Bureau of Alcohol, Tobacco,
Firearms and Explosives

Firearms Technology Industry Services Branch

MAR 09 2018

Submitted Sample: Folding Bicep Version 2

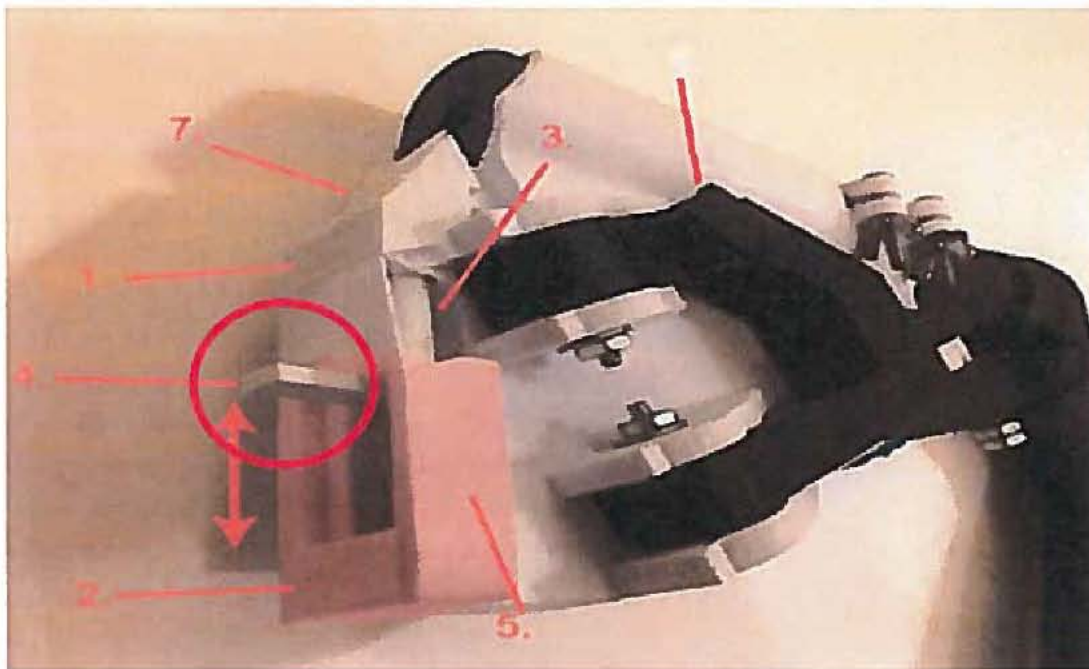
The submitted sample is designed to attach to a KAK dimpled buffer tube (also provided), which allows the sample to be adjusted based on the size of the shooter. The stated purpose of the sample is to serve as a “bicep brace” providing stability while firing an AR-type pistol with one hand. Specifically, you state that “...the purpose of this brace is to allow a shooter to fire a pistol (in this design, an AR-type pistol) using the shooter’s bicep region of their arm for stabilization and recoil transfer.” Further, this design is intended to keep the pistol classified as a “handgun” under the GCA.

In March 2017, FTISB received your request for a letter of approval for a pistol bicep brace. On April 24, 2017 FTISB responded that the design of the bicep brace “allows it to be folded into a compact configuration which resembles an AR-type shoulder stock. FTISB found that the true purpose of the submitted bicep brace is for use as a shoulder stock for an AR-type pistol and that the resulting combination of a pistol and stock meets the definition of a short-barreled rifle and a “firearm” as defined under the NFA, 26 U.S.C. § 5845(a)(3).

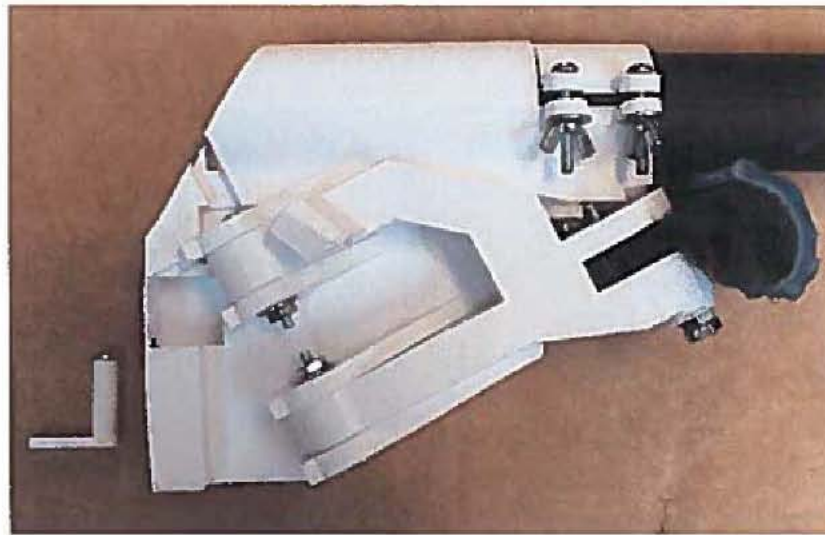
The first modification included the addition of a “large tab” which protrudes from the rear of the sample. The tab is circled in the picture below:

In your correspondence, you discuss that utilizing the sample as a shoulder stock, with this large tab in place, results in “extremely painful” and “excruciating” results. We note however, that compared to many firearms, the recoil from a .223/5.56 is minimal, largely due to the buffer and buffer spring which absorbs recoil and which your design utilizes. Even so, FTISB found that this “large tab” may be easily removed by tilting and pulling it from the sample. Removal of the large tab from the back of the bicep brace creates a flat surface consistent with that of a shoulder stock. Any reasonable person can simply remove the large tab to use the folded Bicep Brace

(Version 2) as a shoulder stock. Therefore, a permanent attachment method for the "large tab" is necessary to prevent misuse of your submitted item as a shoulder stock.

Thus, until such time as a permanent method for attaching the "large tab" to the rear of the Folding Bicep Brace (Version 2), FTISB cannot classify the submitted device as a stabilizing brace and not a shouldering device.

Tab easily removed

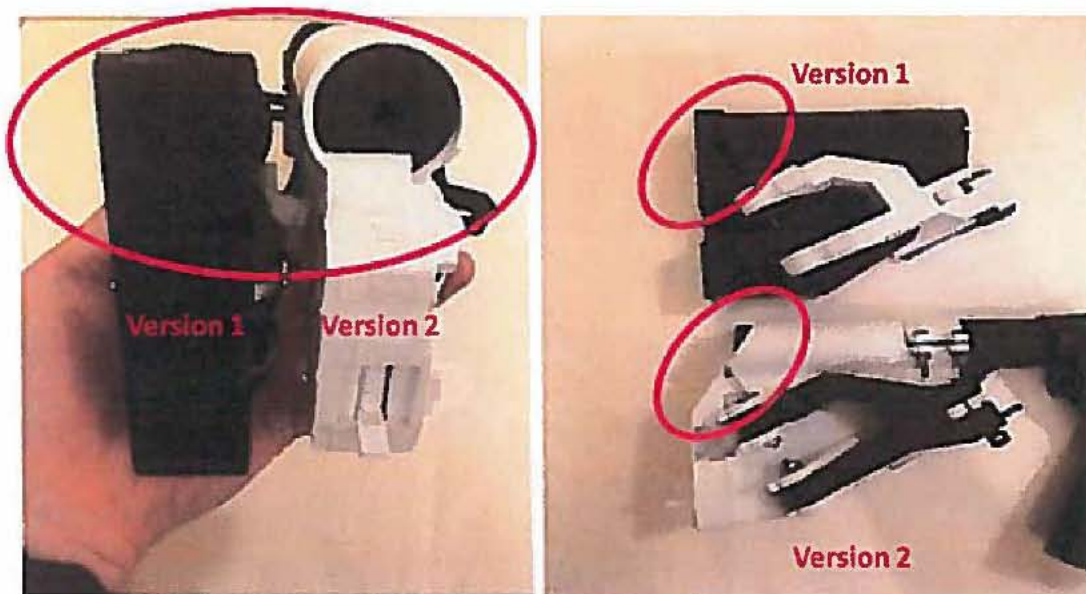
Another modification made to the sample was the removal of a portion of material from the rear of the device, specifically a diagonal cut on the top. You stated that this material was unnecessary to the function of the folding bicep brace design and incidentally made it painful to use as a shoulder stock.

While this successfully removed a portion of the rear of the device, which could be used as a shoulder stock, a large area still remains. This remaining surface area, combined with an easily removable tab, constitute a device for shouldering an AR-type pistol.
